STAFF REPORT: 4/10/2024 MEETING (**REVISED 4/10/2024**)

APPLICATION NUMBER: HDC#2024-00131

ADDRESS: ~~839~~ 836 BATES AND CADILLAC SQUARE PARK, BETWEEN WOODWARD AVE AND RANDOLPH STREET

SCOPE OF WORK: REHABILITATE SIDEWALKS, INSTALL NEW LANDSCAPED MEDIAN IN RANDOLPH STREET, REMOVE EASTBOUND TRAFFIC LANES AT 100 BLOCK OF CADILLAC SQUARE, AND EXTEND CADILLAC SQUARE PARK SOUTHWARD

Current conditions, showing areas proposed for demo and district boundaries in yellow

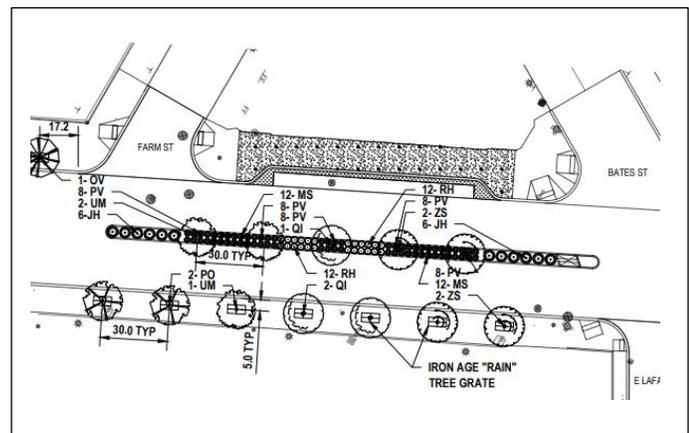
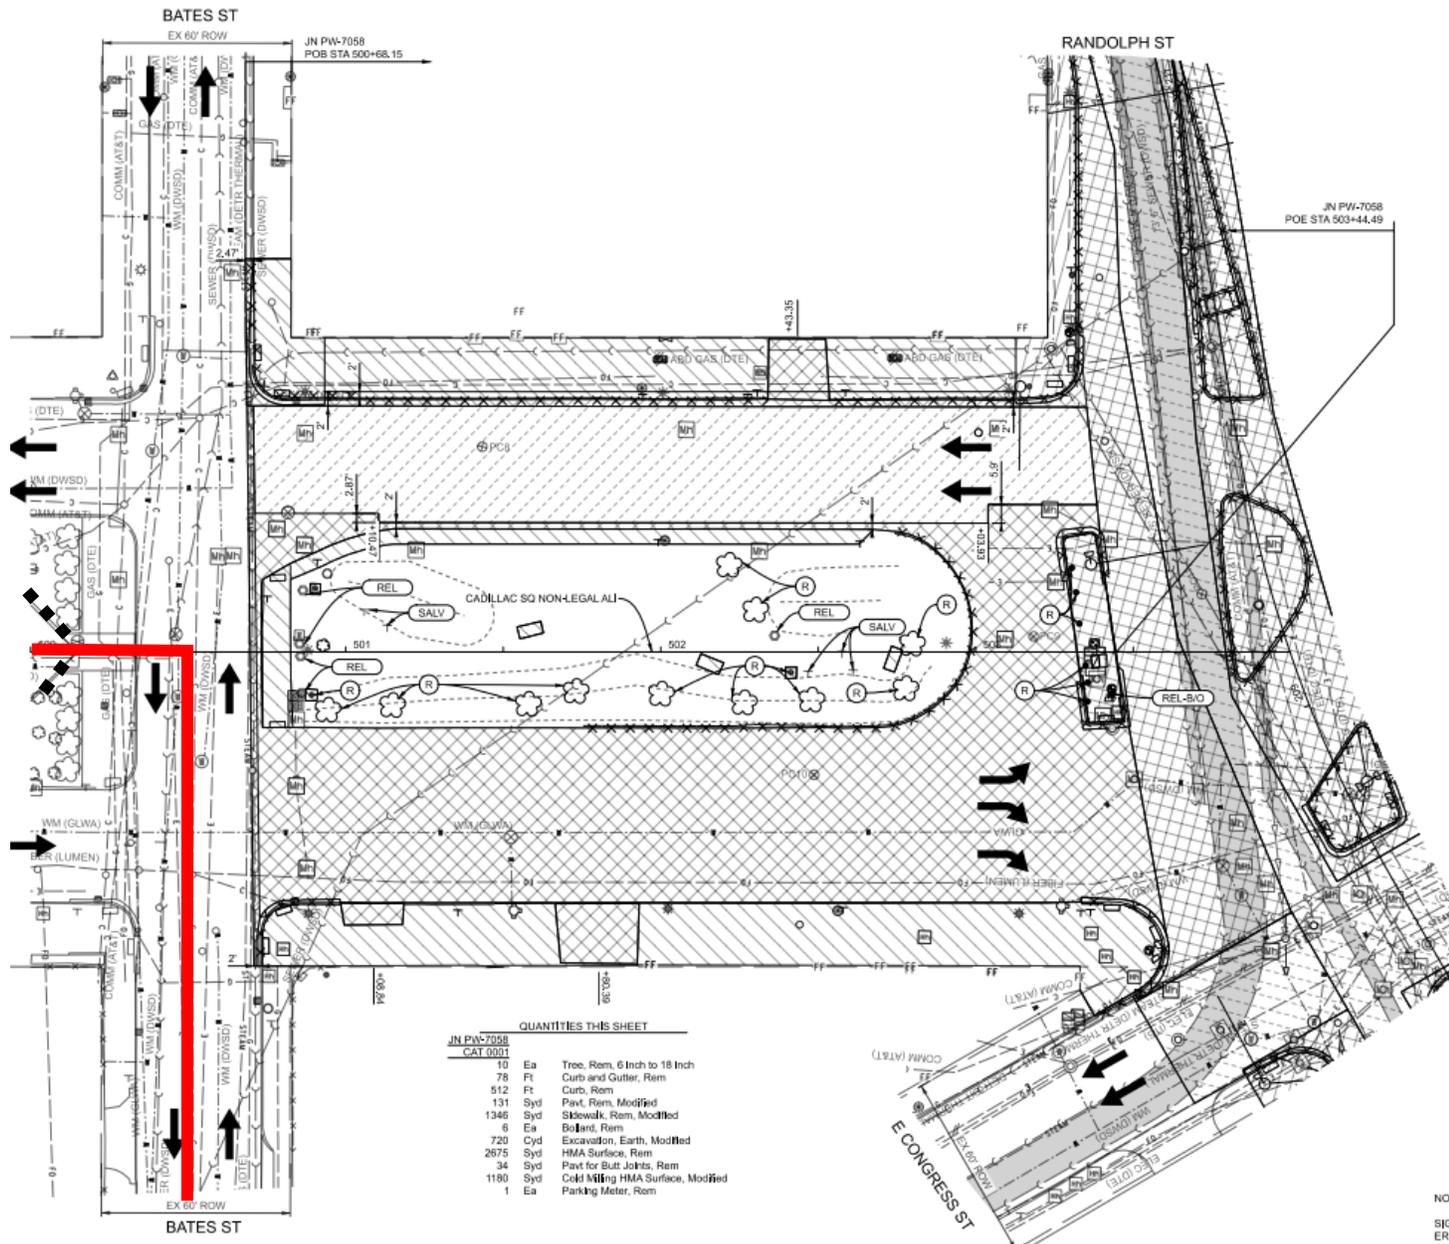
- The work proposed within the public right-of-way in the Water Board Building Historic District will not result in the removal of historic fabric, nor will it have an adverse effect the district’s historic appearance. Staff recommends that the Commission issue a Certificate of Appropriateness for this work.

It is staff's opinion that the project is appropriate to the Water Board Historic District's historic character and meets the Secretary of the Interior's Standards for Rehabilitation. Staff therefore recommends that the Commission issue a Certificate of Appropriateness for the project with the condition that the any revisions/additions to the proposal be submitted to HDC staff for review and approval. If staff determines that the work does not meet the Secretary of the Interior's Standards for Rehabilitation and or does not meet the threshold for administrative review, staff shall forward the work to the Commission for review at a future regular meeting.

Current conditions, showing proposed areas of demolition, Detroit Financial HD boundaries in red and Bagley Fountain HD is outlined in black at the far left margin

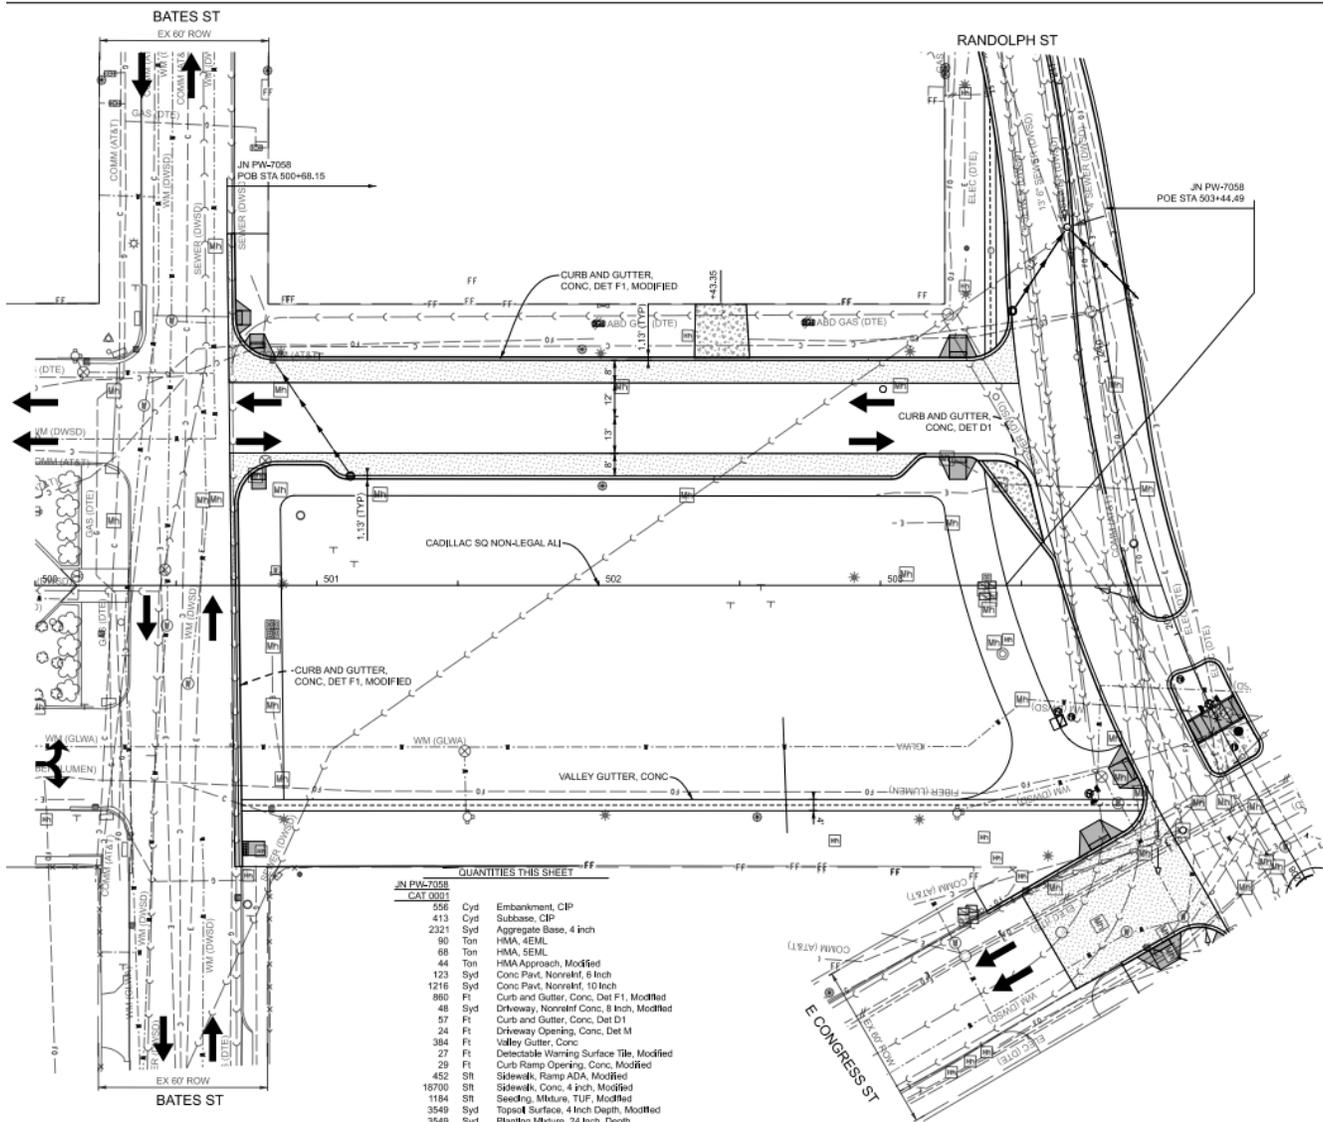
- While the current park does not retain any historic-age material, it does restore the original 1880s park's layout, form and relationship to the abutting public right-of-way (roadways and sidewalks). The new proposal to expand the eastern portion of the park will disrupt this relationship. However, it is staff's opinion that this alteration will have no adverse effect on the adjacent historic districts for the following reasons:
 - The portion of the park within the district has been heavily modified over time and the fountain was only recently moved to its current location
 - Bates Street serves as an effective buffer between the project area and the portion of the park within the district

As previously stated in the above *Research and Observations* section, staff recommends that the project will have no effect on the Water Board Historic District, Detroit Financial Historic District, or the John J. Bagley Fountain Historic District.
